RESOLUTION HOLDING HEARING ON REQUEST FROM HUBBELL REALTY COMPANY (OWNER), REPRESENTED BY CALEB SMITH (OFFICER), FOR REVIEW AND APPROVAL OF PUD FINAL DEVELOPMENT PLAN FOR “GRAY’S STATION PLAT 5 TOWNHOMES AND CLUBHOUSE,” FOR PROPERTY LOCATED IN THE VICINITY OF 1300 TUTTLE STREET

(SITE-2022-000153)

Communication from the City Plan and Zoning Commission advising that at their February 2, 2023 meeting, the following action was taken regarding a request from Hubbell Realty Company (owner), represented by Caleb Smith (officer), for the following regarding property located in the vicinity of 1300 Tuttle Street:

NEW FRONT ELEVATION

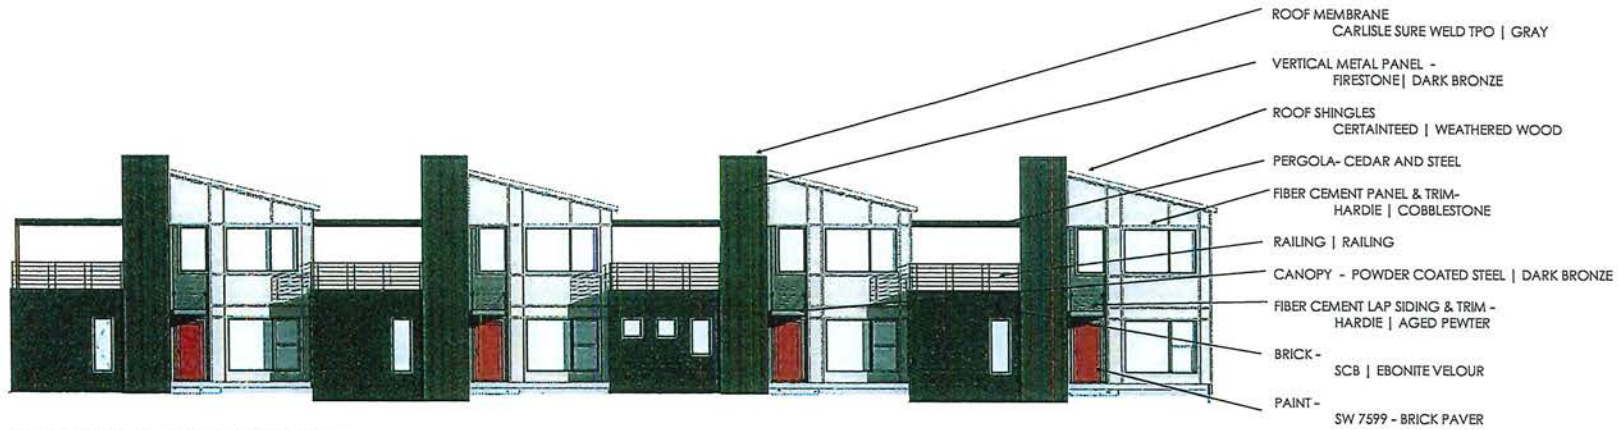
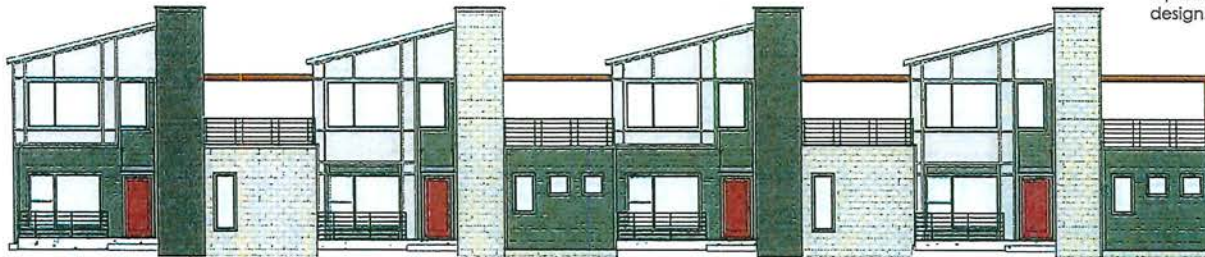
This elevation looked too busy and had too many design themes and variations.

- Revised vertical elements to all be the same color and revised material to dark metal panels with a vertical pattern.
- The cube-shaped building elements were revised from Hardie lap siding/stone to all stone, to unify the overall building design.

NEW FRONT ELEVATION

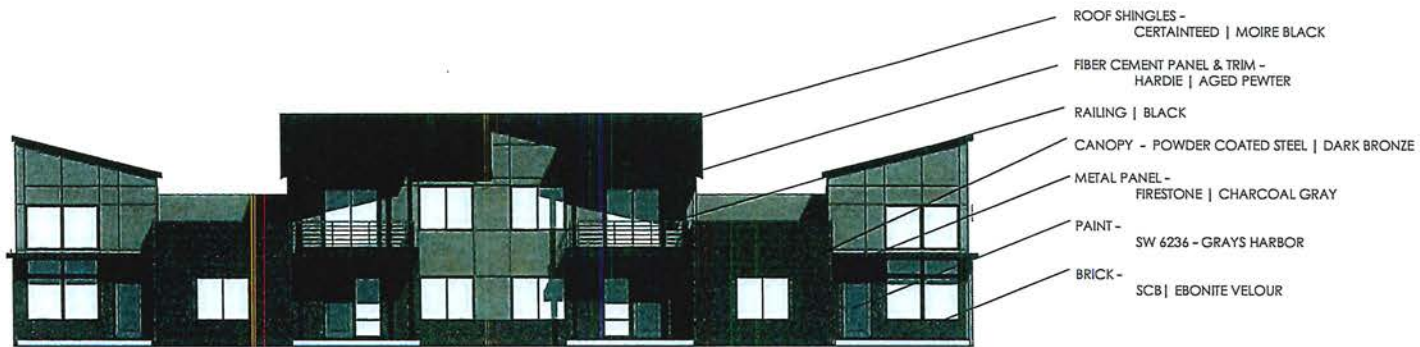
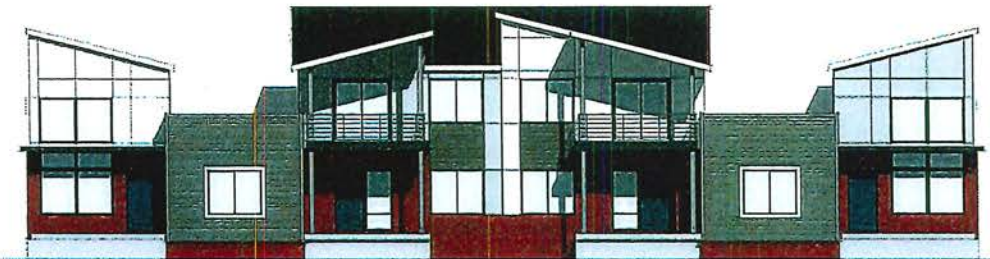
This elevation was too busy and the color scheme too light for this urban environment.

- Changed to a darker color scheme to achieve a more urban look.
- Changed Hardie lap siding on front to metal panels.
- Eliminated the white-colored Hardie panels and matched the panel color on both sides to achieve a unified appearance.
- Steel metal posts will be painted dark gray.
